# USE ON REVIEW REPORT

▶ **FILE #:** 4-F-19-UR

▶ **PROPOSED USE:** Retail business and restaurant with drive-thru.

▶ **APPROVE** the request for the retail business with approximately 15,000 square feet and restaurant with drive-thru with approximately 1,750 square feet as shown on the development plan, subject to 10 conditions.

**MPC01**  
 SITE LAYOUT PLAN  
 DRAWING

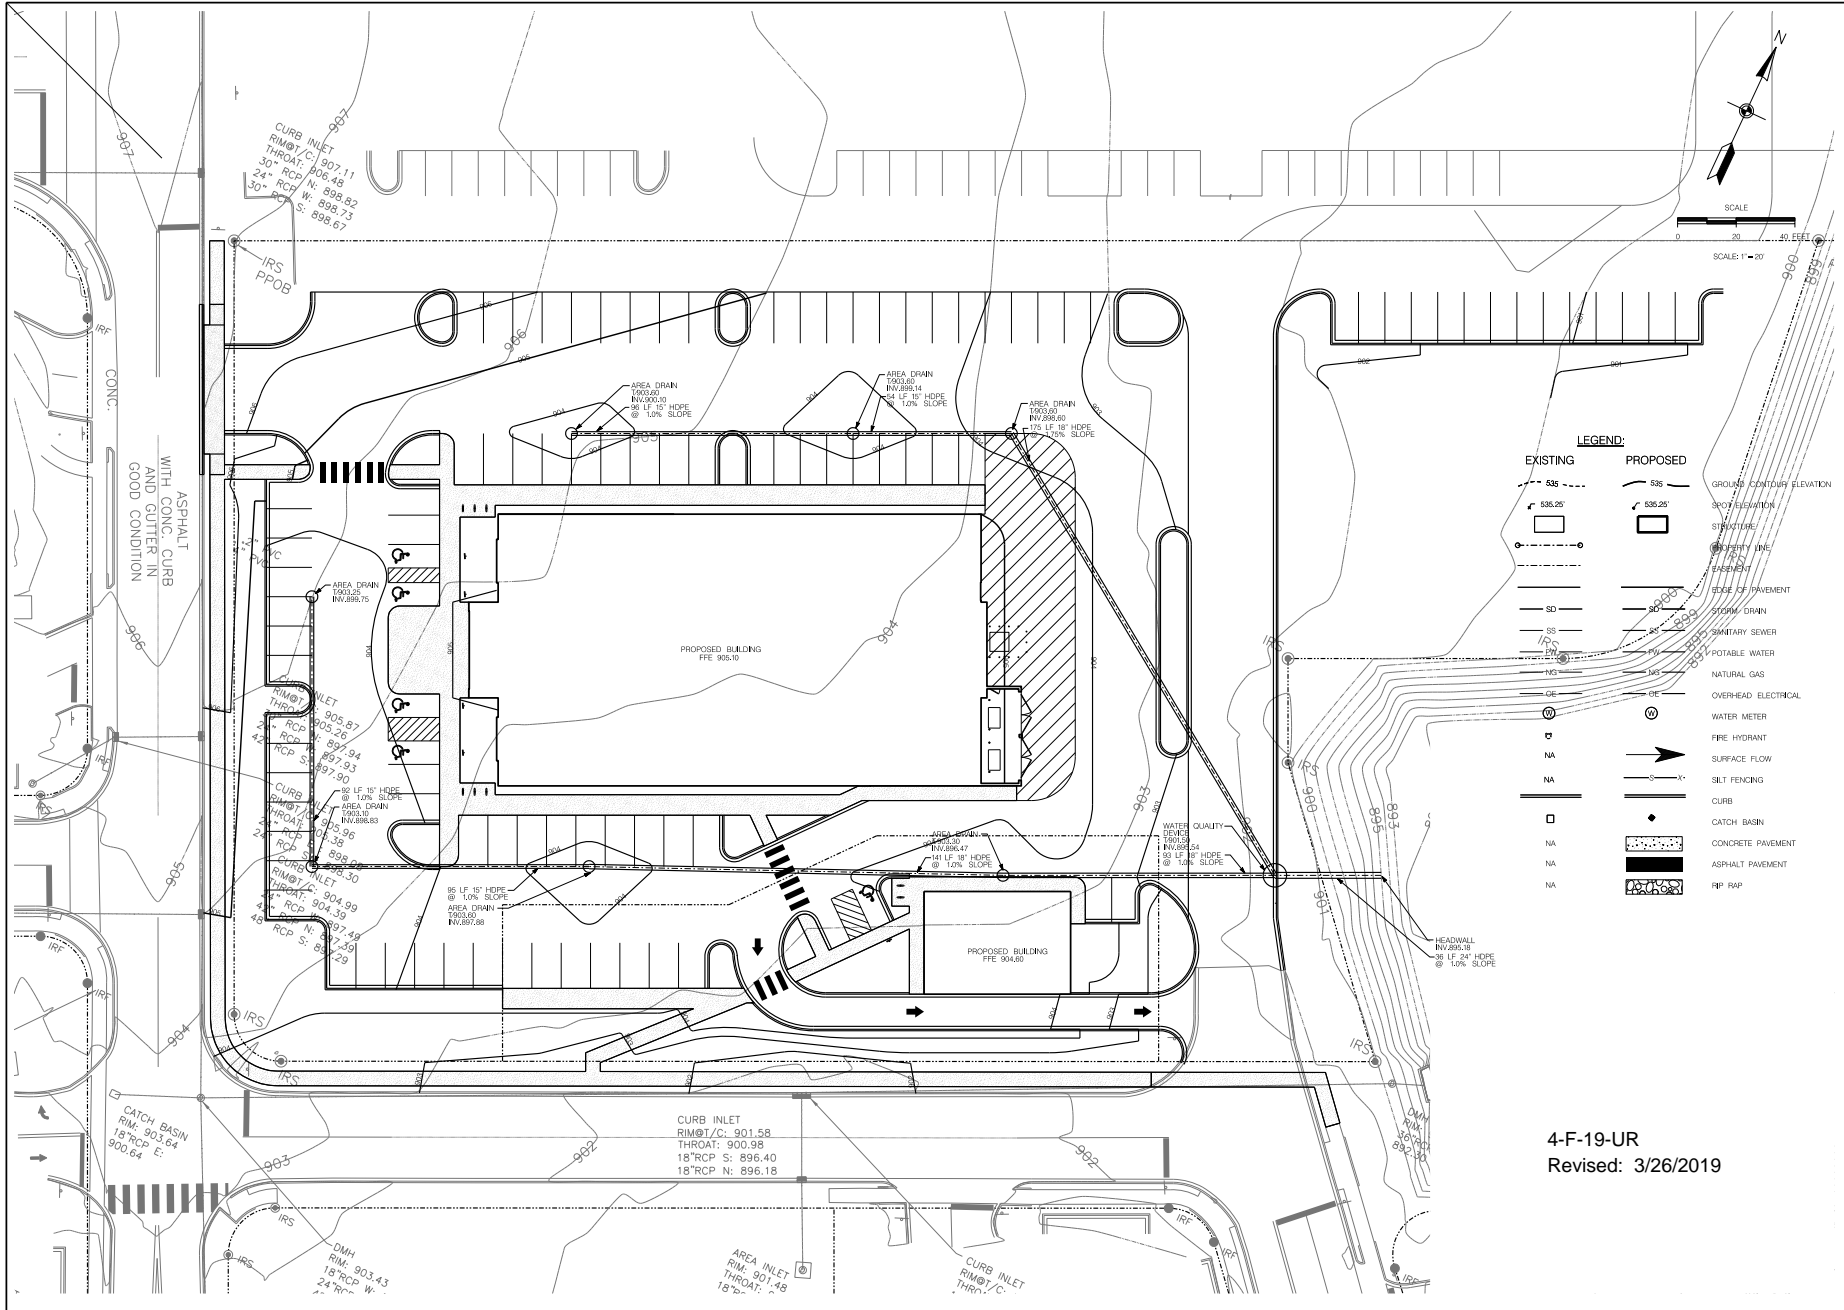
3. Meeting all applicable requirements of the Knoxville Department of Engineering.
4. Provide a landscape terminal island at the eastern end of the row of parking along the northern side of the Duluth Trading building.

7. Relocation of the existing fire hydrant that is at the eastern end of the proposed drive thru lane for the restaurant.
8. Any proposed subdivision of this lot will require approval from the Planning Commission or Planning staff as required by the Knoxville-Knox County Subdivision Regulations. Each lot will be required to meet the parking standards of the Knoxville Zoning Ordinance.

Planting Plan

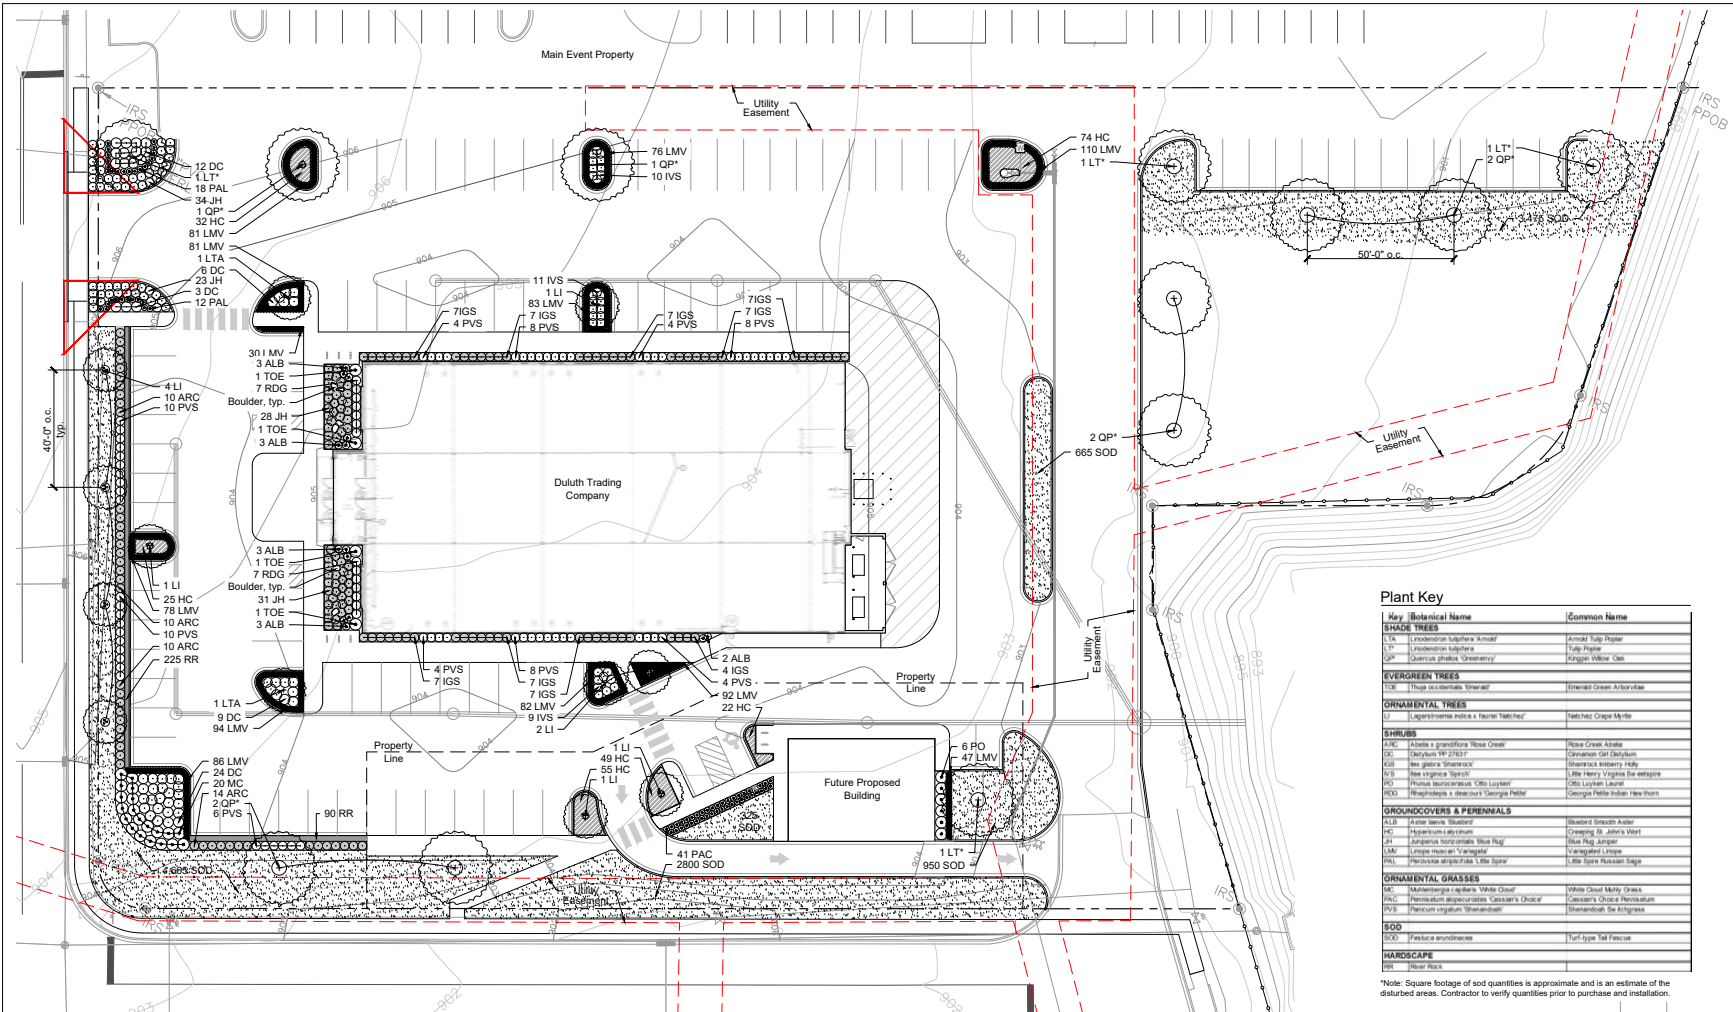
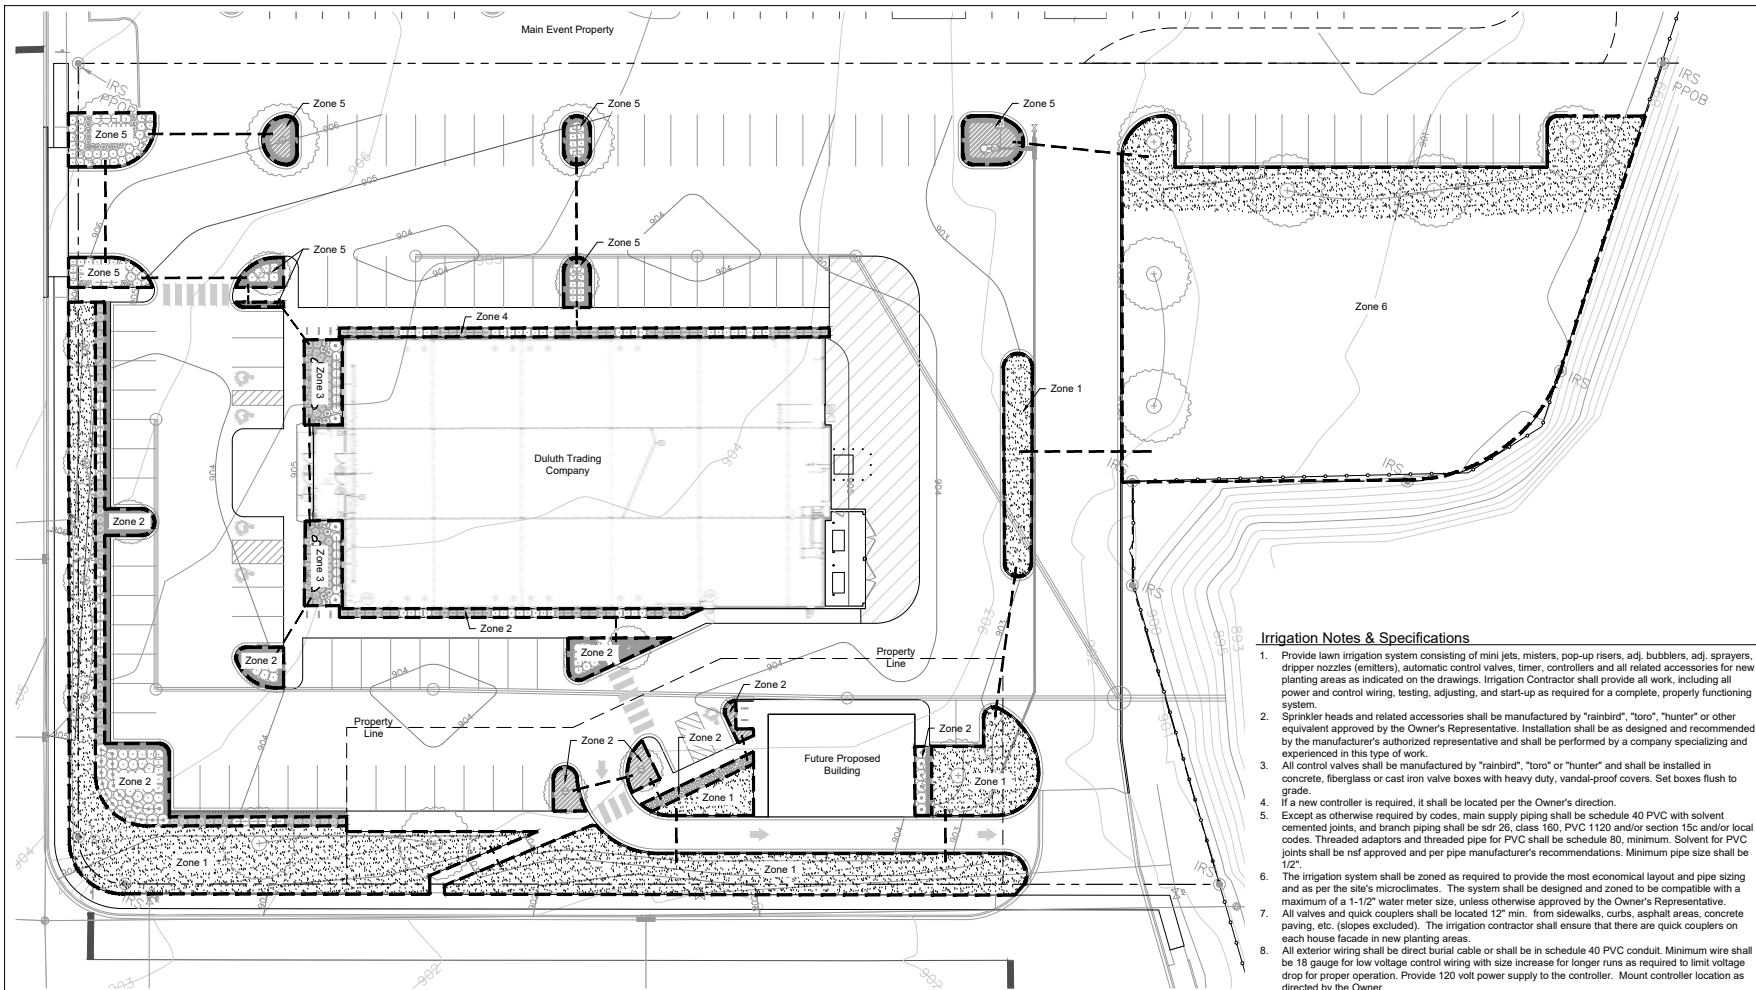
5. Installation of the landscaping as identified on the landscape plan within six months of the issuance of an occupancy permit for this project.
6. Meeting all applicable requirements of the Knoxville Urban Forester.

**E**  
.01 East Elevation  
Scale: 1/16" = 1'-0"

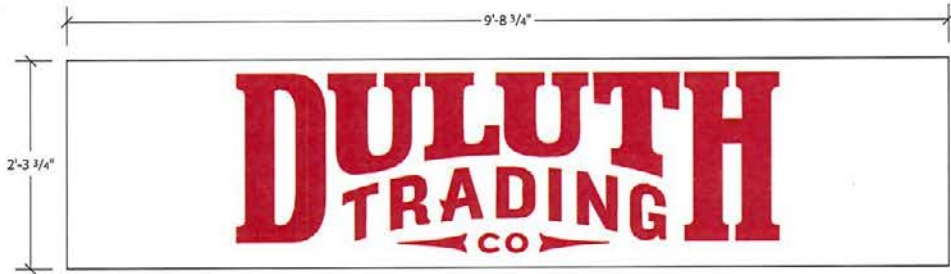
9. Approval of the business sign panels on the two development directory signs and that the attached building signs be modified in order to come into compliance with the sign regulations.

Staff is recommending approval of the business sign panels on the two development directory signs and that the attached building signs be modified in order to come into compliance with the sign regulations. Because the Kingston Corner development was approved with a Master Sign Plan, pursuant to Zoning Ordinance Article VIII, Section 9.3, variances from the sign regulations are not permitted.

**D** Tenant Vinyl  
 .01 Scale: 1/2" = 1'-0"

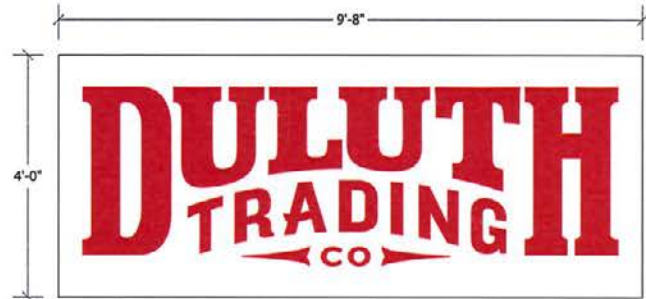
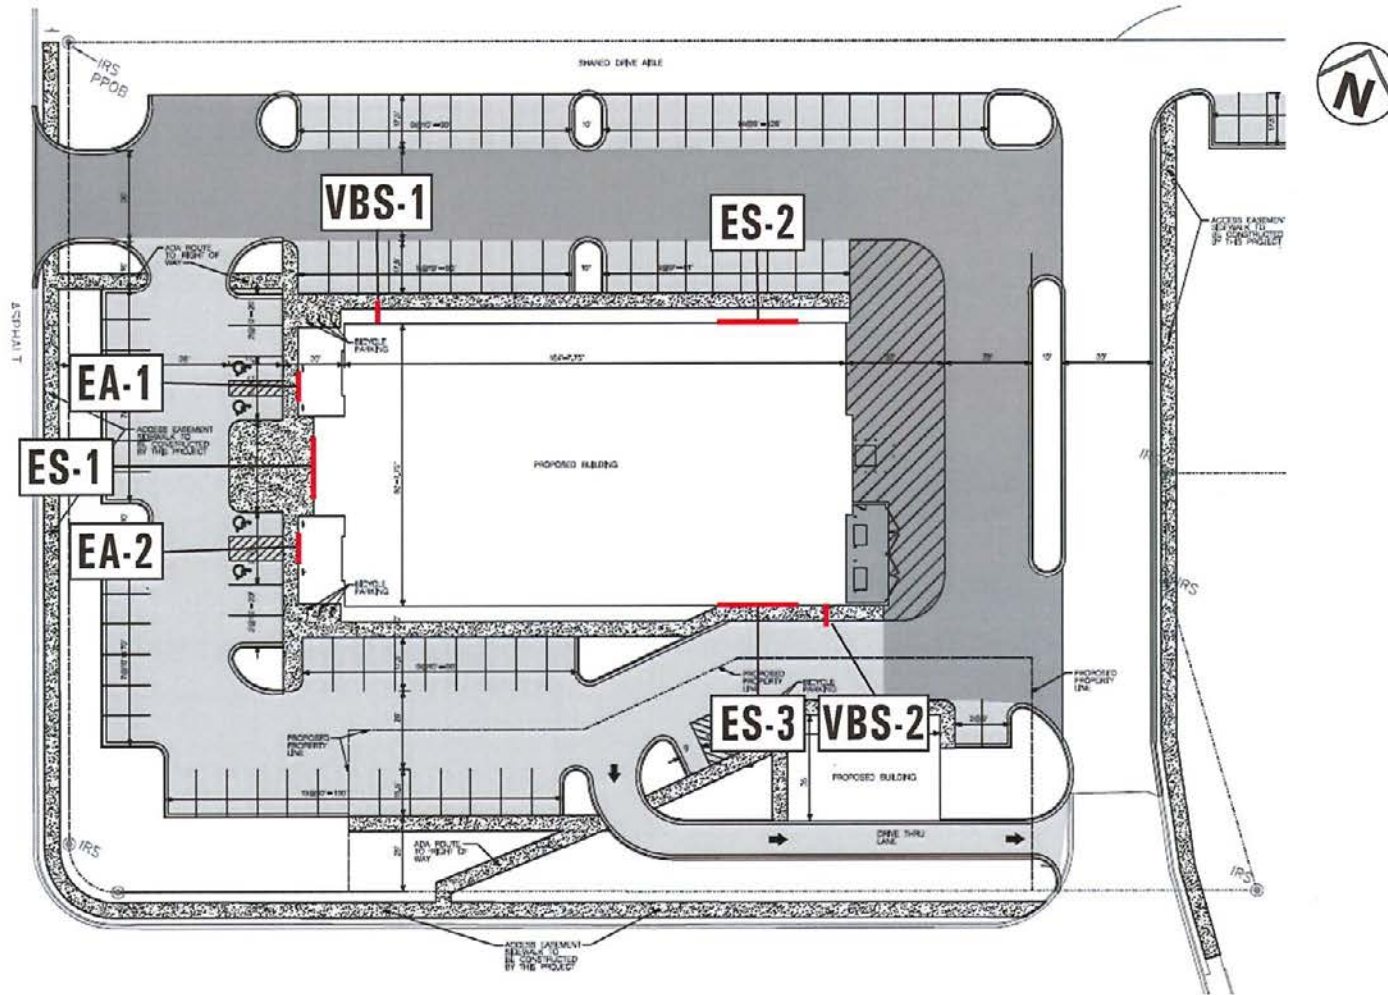
Proposed signs for Duluth Trading Co. include the business sign panels on the two development directory signs (detached signs) located on N. Cedar Bluff Road and Kingston Pike at the two signalized intersections providing access to the Kingston Corners Commercial Subdivision, and the attached building signs. The proposed building signs at approximately 400 square feet, exceed the maximum of 203 square feet allowed for the building based on the proposed building elevations.

Knoxville Zoning Ordinance Article VIII, Section 11.6.e.5. (see attachment) allows the Planning Commission to approve additional signs in the PC-1 zoning district under certain conditions. It is staff's position that this provision applies to detached signs which are restricted in number and not attached building signs which are not restricted in number, only in sign area. When the master sign plan was approved for Kingston Corner Commercial Subdivision, two development directory signs (detached signs) were approved that are located on N. Cedar Bluff Road and Kingston Pike at the two signalized intersections providing access to the development. These two signs which will include panels for Duluth Trading Company were approved to allow identification on the two main streets of businesses that did not have frontage on those streets. It is Staff's position that these signs meet the intent of Section 11.6.e.5.
